Note A-

01		See Note A	03-14-2022			
Ed	Posi- tion	Modified from	Date	Intr./Appd.	Parent 3D model	Ed . Version 3D

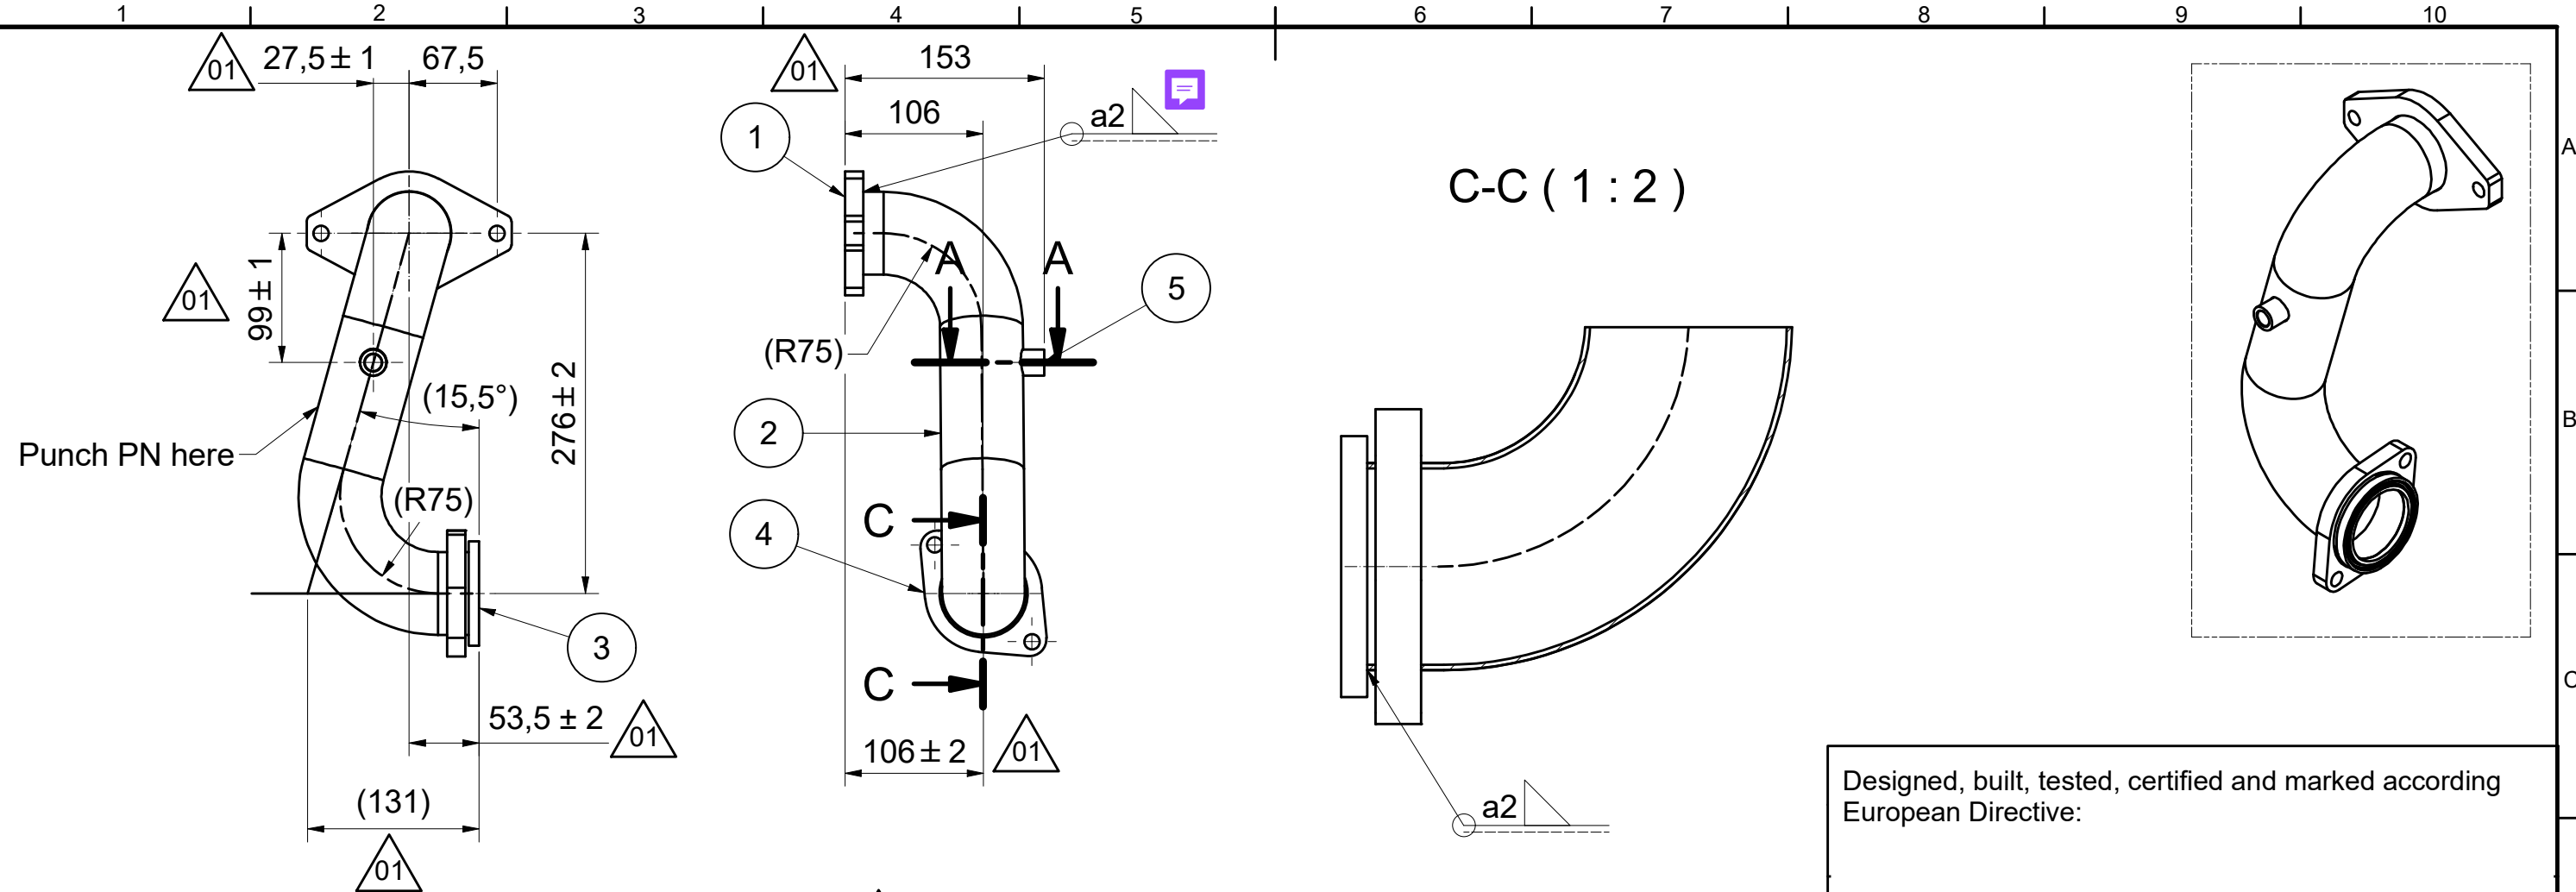
- Bending radius is changed from 76 to 75.
- Welding socket position is changed.
- Dim. 106 & 53.5 are added.
- Weld Socket dia. changed from 17.5 to 20.
